SERVICE BULLETIN

APPLICABILITY: 2015-2019MY WRX

NUMBER: 07-146-19

SUBJECT: Engine Wiring Harness- Design Change

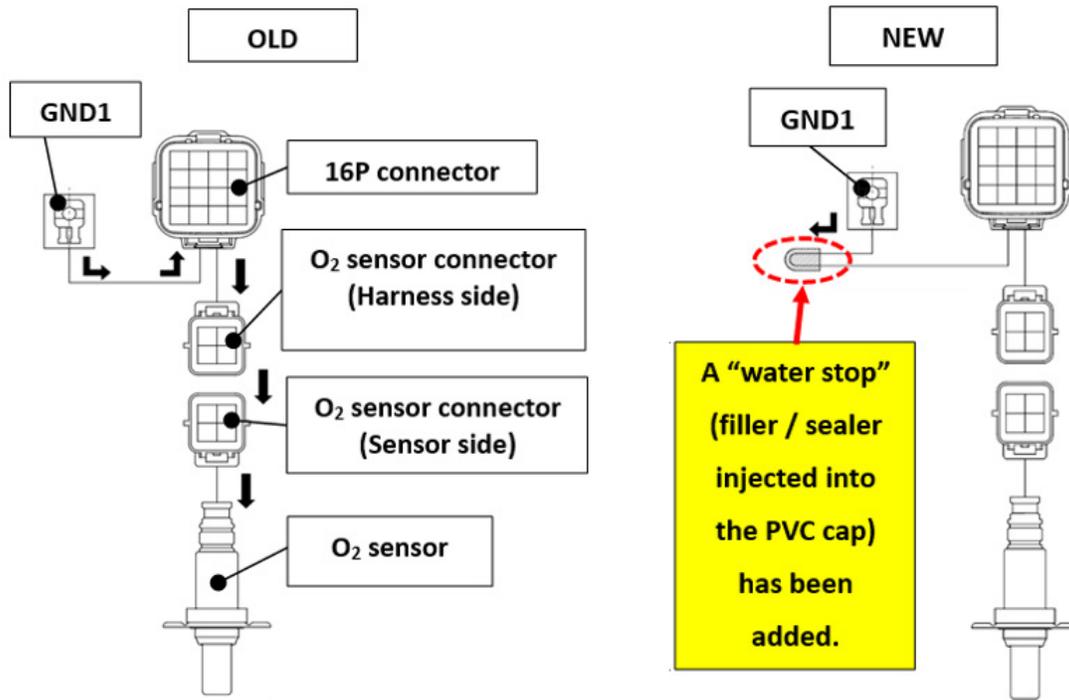
This bulletin announces a design change made to the engine wiring harness to improve resistance to moisture. A detailed illustration describing the change is supplied below.

Description	Part Number	Application
HARNES-ENGINE	24020AF983	2015-17MY
	24020AG431	2017-19MY

NOTE: This part change was made during 2017MY production therefore, always order the most up-to-date part number based on the specific VIN of the vehicle being repaired.
